***Replacement of T12 & T13 at Kirkland Lake TS  
Notification of Conditional Approval of Connection Proposal  
CAA ID Number: 2012-EX628***

**Final Report - Expedited System Impact Assessment**  
**Hydro One Networks Inc.**

**1.0 GENERAL DESCRIPTION & PROPOSED MODIFICATIONS**

**Figure 1 – T12 and T13 Load at Kirkland Lake TS**

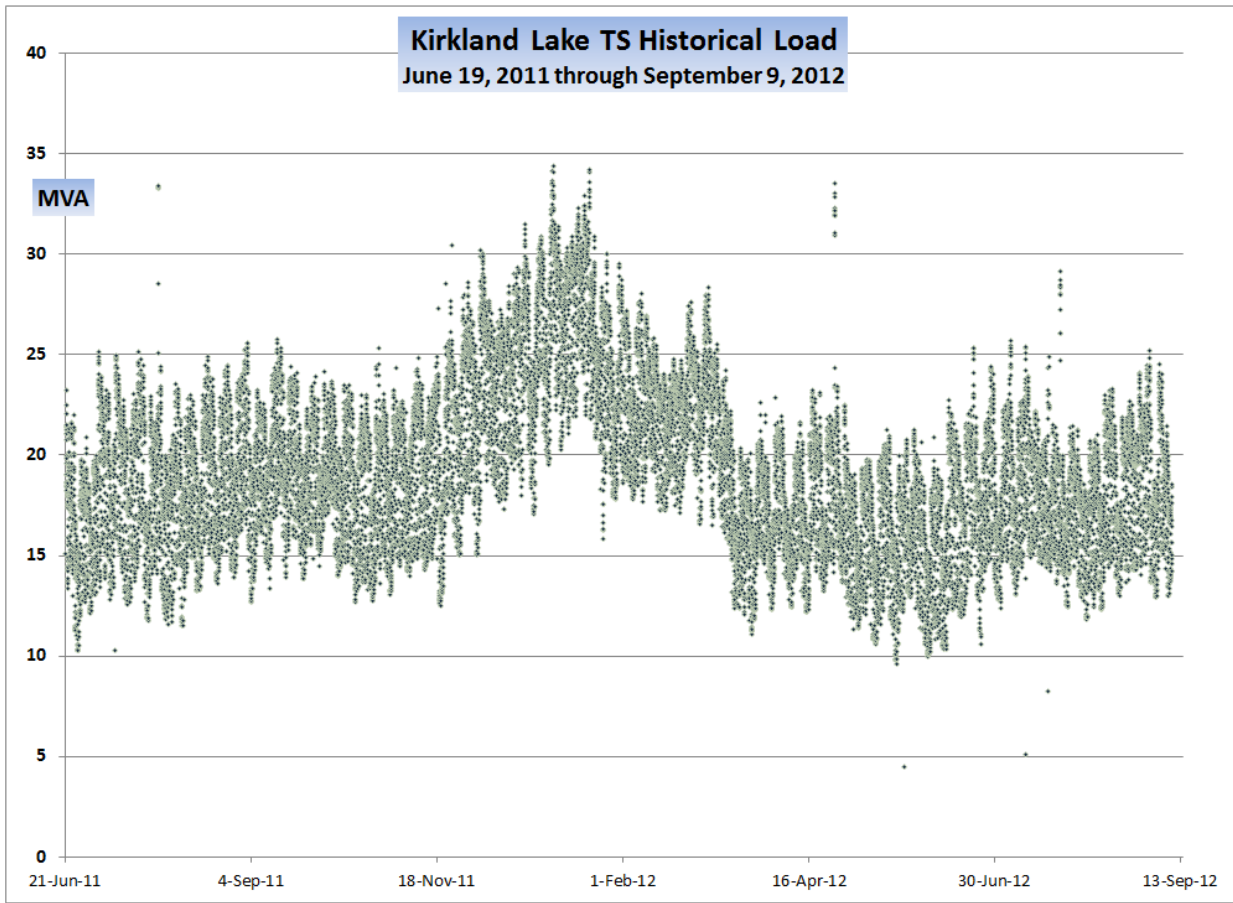
The peak load of 34.4 MVA at Kirkland Lake TS occurred on January 3, 2012 at 17:30. The figure below shows the loading at the LV side of T12 and T13. This peak load is below the existing 10-DAY winter capability of 61.9 MVA and also below the assumed new 10-DAY winter capability of 61.9 MVA at Kirkland Lake TS.

The 10-Day winter transfer capability at Kirkland Lake TS will not be exceeded in the foreseeable future.

**Figure 2 – Load Angle at Kirkland Lake TS**

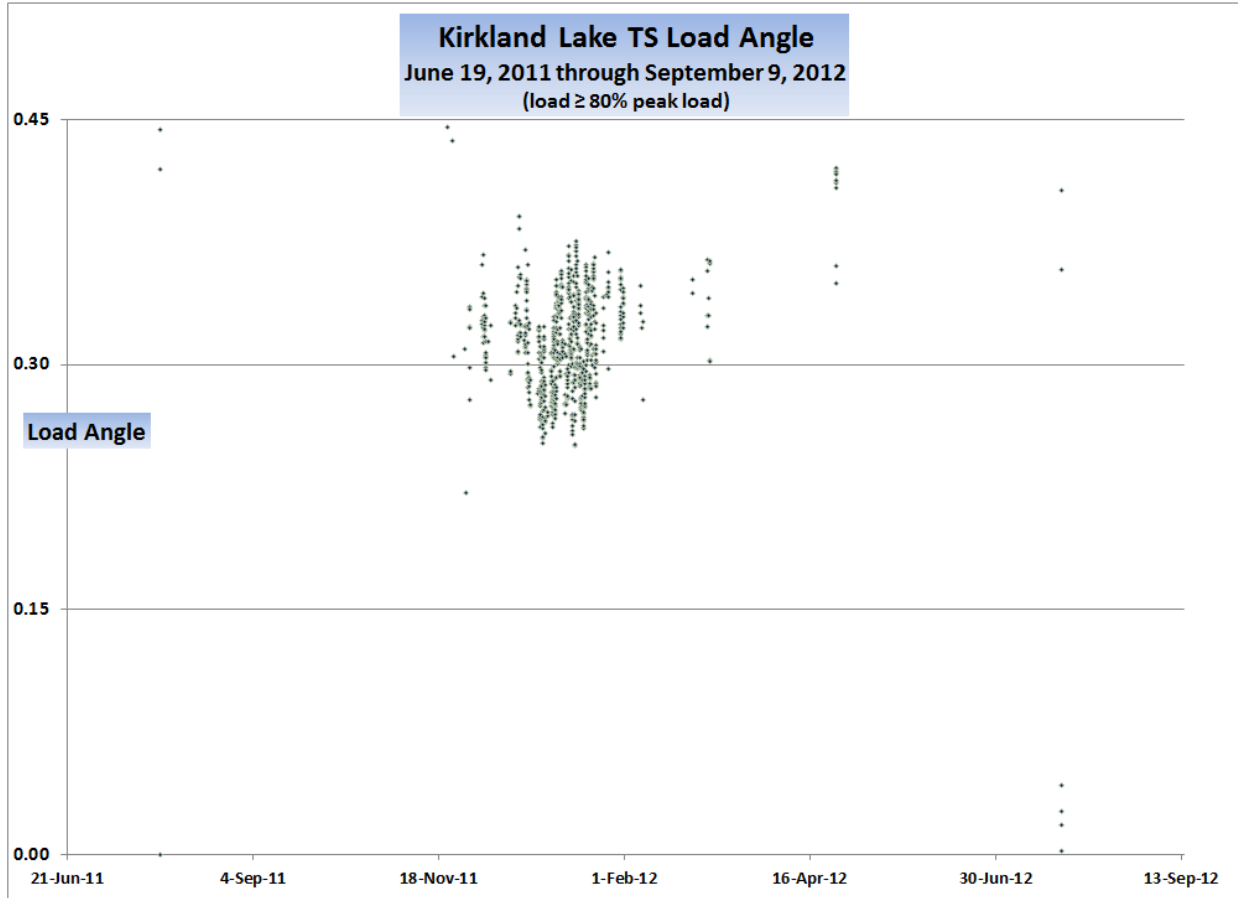
Revenue meter information from June 19, 2011 through September 9, 2012 was used to evaluate the load angle on T12 & T13 at Kirkland Lake TS. The figure below illustrates the load angle on the LV side of T12 and T13 for instances when the load is above 80% of the peak load.

Between June 19, 2011 and September 9, 2012, the load angle at Kirkland Lake TS was within the IESO required limits for instances when the load is above 80% of the peak load.

The Market Rules require that Hydro One have the capability to maintain a power factor within the range of 0.9 lagging and 0.9 leading as measured at the defined metering point at Kirkland Lake TS. This power factor range translates into a load angle range of  $\pm 0.45$  radians. All the points above 0.45 radians indicate a lagging power factor below 0.9. All points below -0.45 radians indicate a leading power factor below 0.9.
